Objection to: Blanchardstown Bus Corridor, Case Reference: KA29N.313961

As a resident of Connaught Street I wish to strongly object on behalf of my family to the proposed alterations to the current road network in and around my area proposed in order to facilitate the Blanchardstown Bus Corridor.

**Proposed CBC –
Estimated change in
road traffic with CBC in
place (AM Peak 2028)**

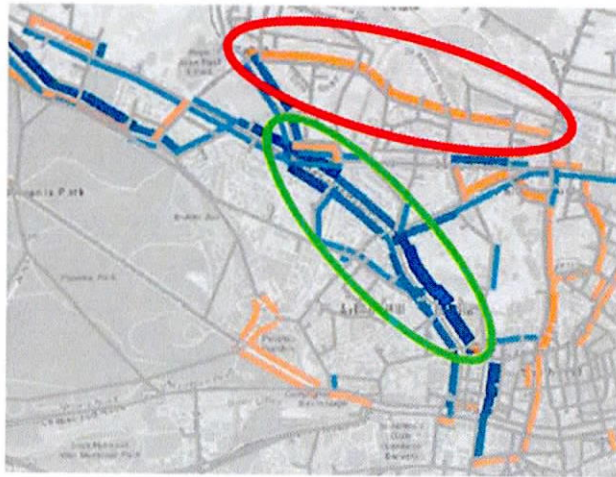
Modelled traffic flows for our road have also increased significantly since the NTA's Route 5 traffic modelling report (Nov. 2020. Pg 104) which illustrated the impact that closing Old Cabra Road to private traffic would have on the surrounding area. The major decrease in traffic volumes for Stoneybatter (circled in green) were forecasted to bring about major increases on the Fassaugh Avenue/Connaught Street corridor (circled in red):

When this report was released Connaught Street was projected to experience an additional 200-300 vehicles per hour during the morning peak. We already have a perennial queue of traffic for the junction with Phibsborough Road. We raised our concerns even with this lower proposed traffic flow increase at that time (see submission attached in Appendix 1). Bearing in mind this appears to have been compared with current baseline – which is not available to us in this current submission.

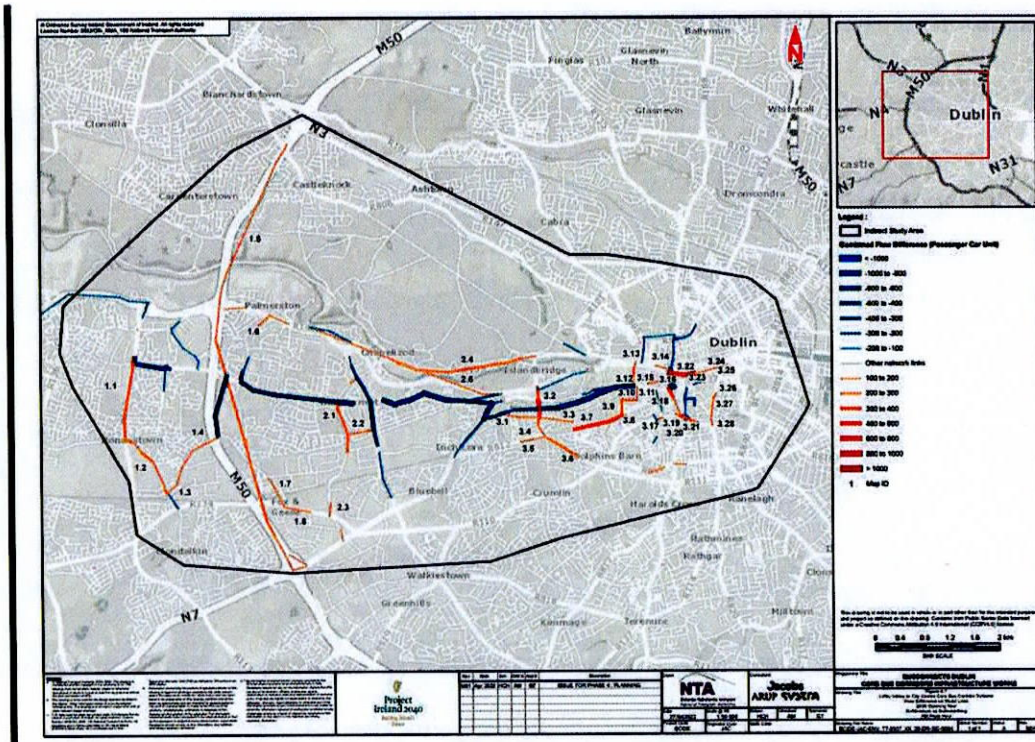
- **Flawed classification system of the impacts which sees areas forecast to experience an 80% increase in traffic flows being described as a “low impact” change.** In appendix A6.4 of the EIAR, Impact Assessments, the following are estimated when comparing a “Do Minimum” with a “Do Something” (i.e., BusConnects) scenario at PM peak hour:
 - An 80% increase in hourly traffic flows at the junction of Connaught Street and Shandon Crescent,
 - A 55% increase in hourly traffic flows at the junction of Fassaugh Ave and Dingle Road,
 - A 64% increase in hourly traffic flows at the junction of Fassaugh Ave and Bannow Road.

Each is described as having “not significant” effect and “negligible” impact.

Furthermore, there is an estimated 70% increase in peak hourly traffic flows at the junction of Connaught Street and St Peter’s Road. This was described as being a “low impact” with “moderate” effect. It appears that only areas that are forecast to experience increases in traffic volume to beyond 85% of road capacity are classified as having any impact at all.
